#### 1.0.3.1 Thermal Topical Report

HOLTEC INTERNATIONAL COPYRIGHTED MATERIAL		
HI-STORM 100 FSAR		Proposed Rev. 22A
REPORT HI-2002444	1-6

Figure 1.0.1: Thermal Topical Report Implementation

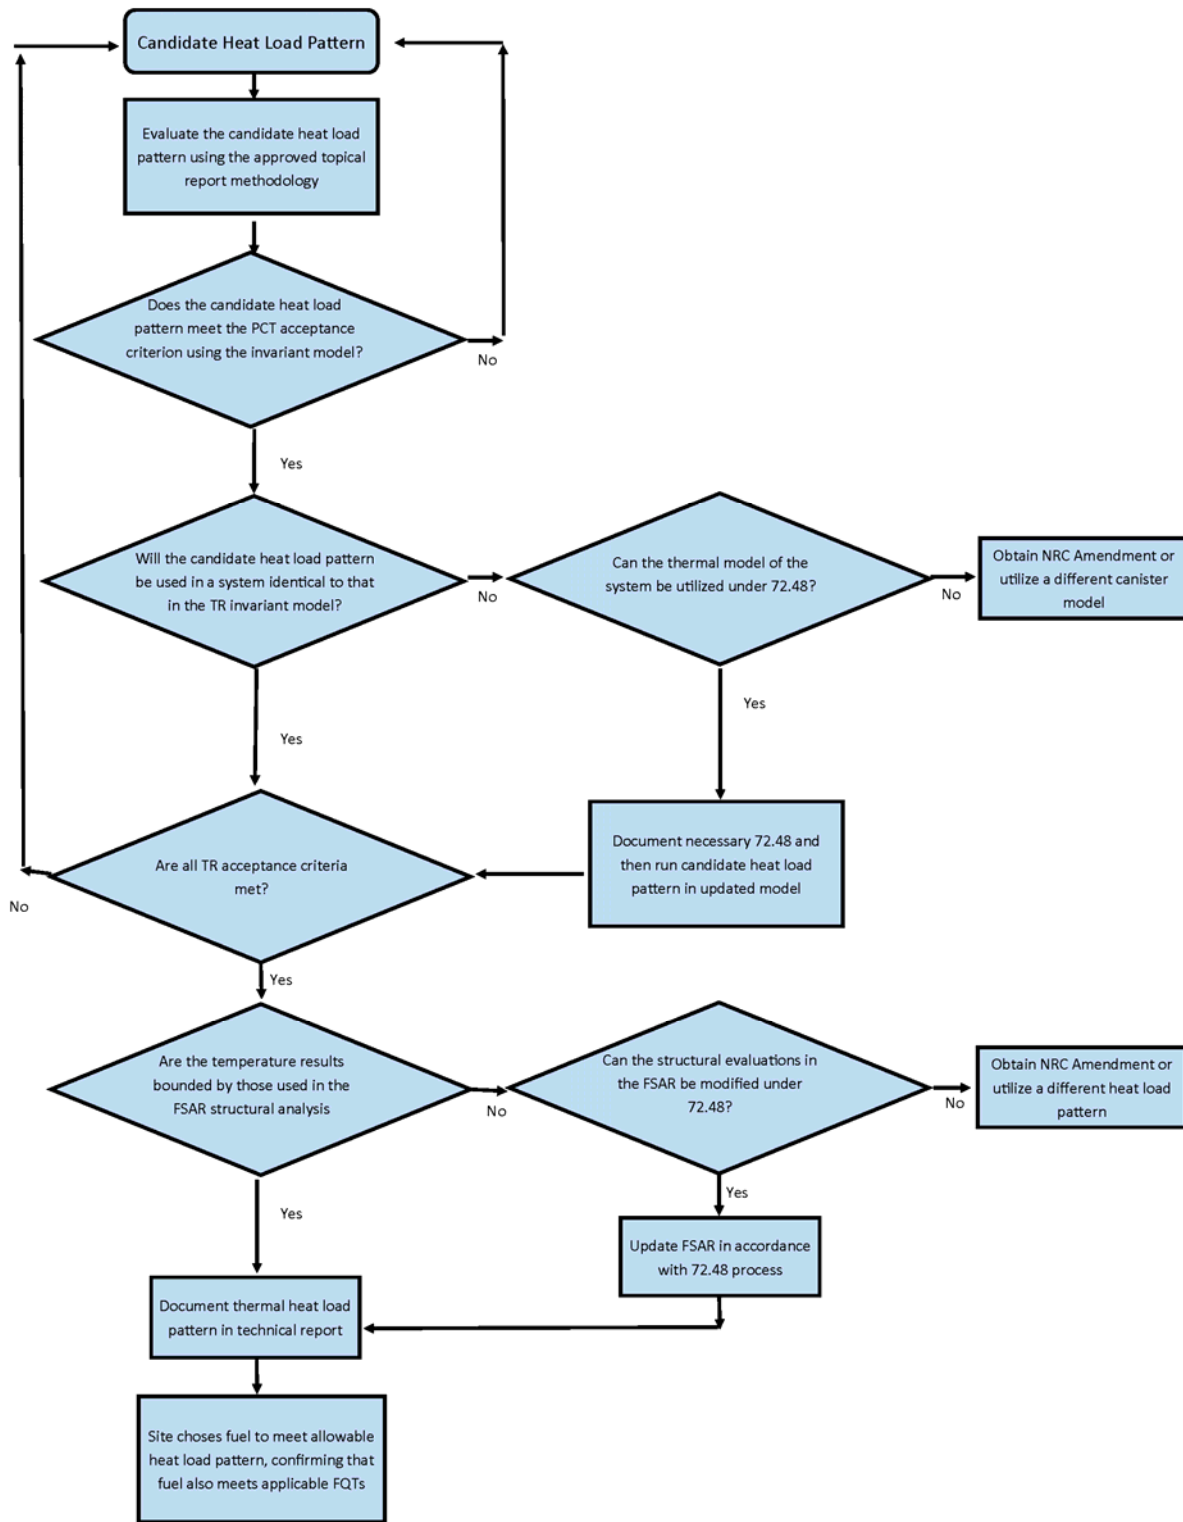
The NRC has reviewed and approved Topical Report HI-2200343 [1.0.7]. This report outlines a methodology for developing heat load patterns for each canister. Throughout this FSAR, the areas where the topical report can be applied are identified. However, since the topical report itself is specifically focused on the thermal methodology, this section provides an outline of the approach for implementing that methodology. For additional clarity, a flowchart of the process is included in Figure 1.0.1.

Because the topical report SER describes the model used as “invariant,” the first step in any use of the topical report is to evaluate the proposed heat load pattern using the exact model from the topical report. Once it has been demonstrated that the heat load pattern meets the peak cladding temperature requirements in the topical report model, then the heat load pattern can be considered acceptable, similar to any of the explicit patterns listed in the CoC.

After the heat load pattern is shown to meet the peak cladding temperature in the invariant topical report model, then any required changes to the model can be considered under the 10CFR72.48 process. If the changes do not require prior NRC approval, they can be incorporated following Holtec's 10CFR72.48 process. Then the heat load pattern should be run in the revised model, following the methodology in the Topical Report, to ensure that all the acceptance criteria are still met.
